**ZC04-06-047**

## ZONING STAFF REPORT

Date: February 22, 2005  
Case No.: ZC04-06-047  
Prior Action: Tabled indefinitely (06/01/04)  
Posted: 02/11/05

HWY. 1077 SUBDIVISION  
 SECTION 17, TOWNSHIP 6 SOUTH, RANGE 10 EAST  
 ST. TAMMANY PARISH, LOUISIANA

**Z-1**

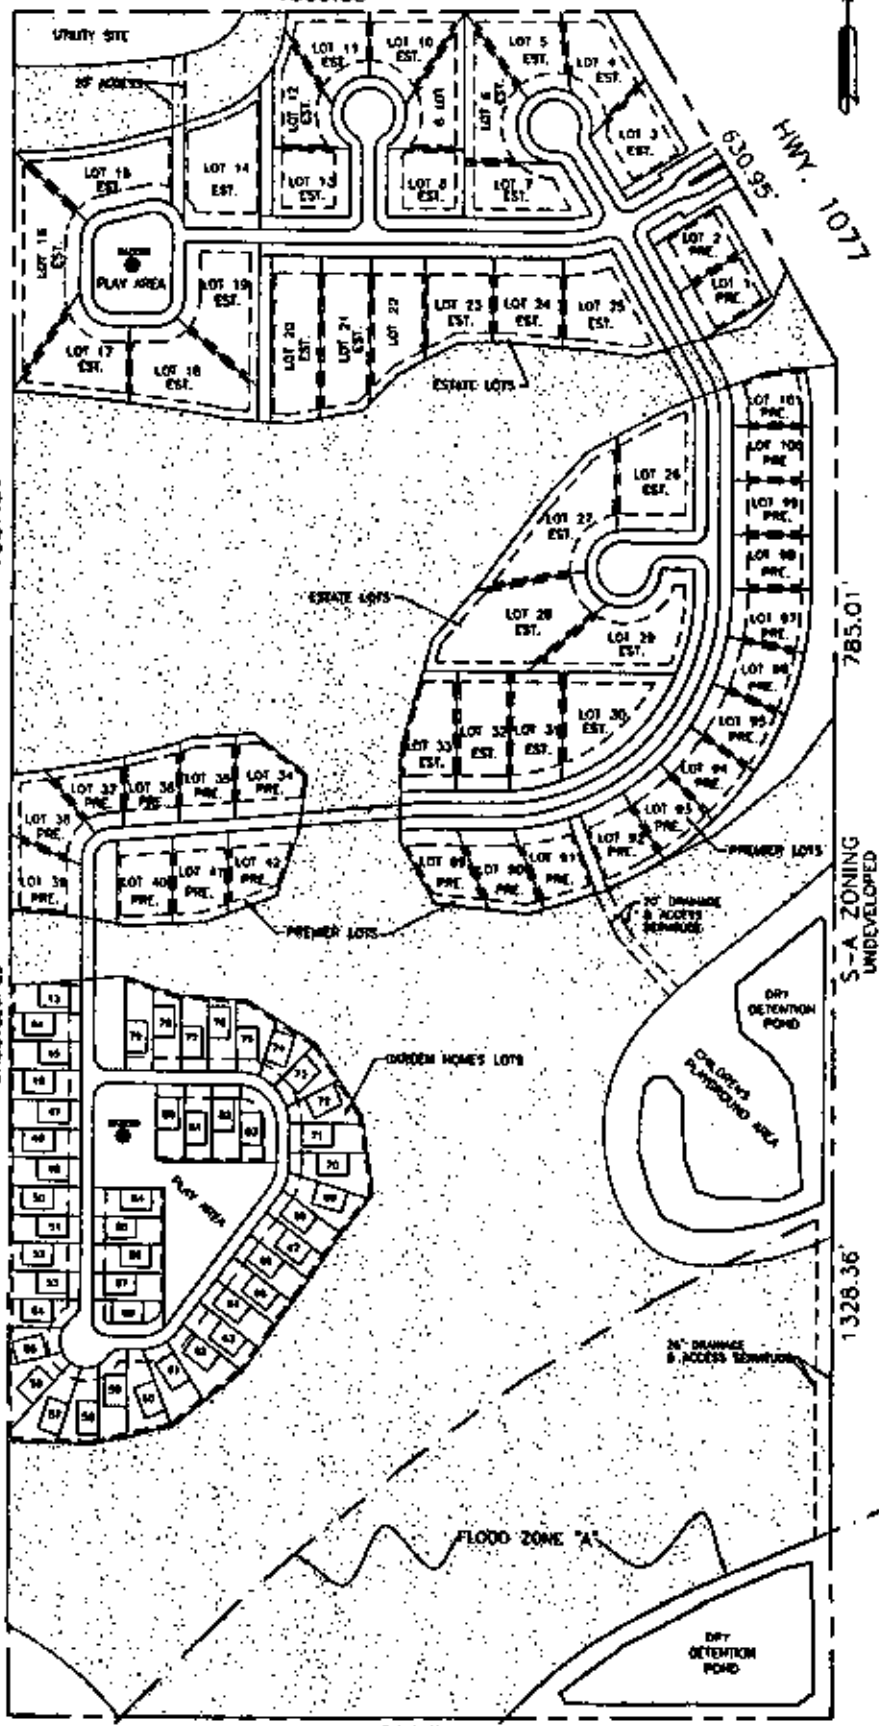
on dedicated greenspace area through the development. However, no passive amenities are being provided. Staff feels that, considering that 50 of the 78 acre development is dedicated for greenspace, additional passive and active amenities must be provided. Considering that one of the objective of the PUD, is to provide "functional and beneficial uses of open space areas", the total greenspace area provided, shall be redesigned.

The project is proposed to be constructed in two phases. Construction of the first phase is expected to begin in October 2005 and the second phase is expected to begin in October 2007. Note that the phases must be shown on the plan.
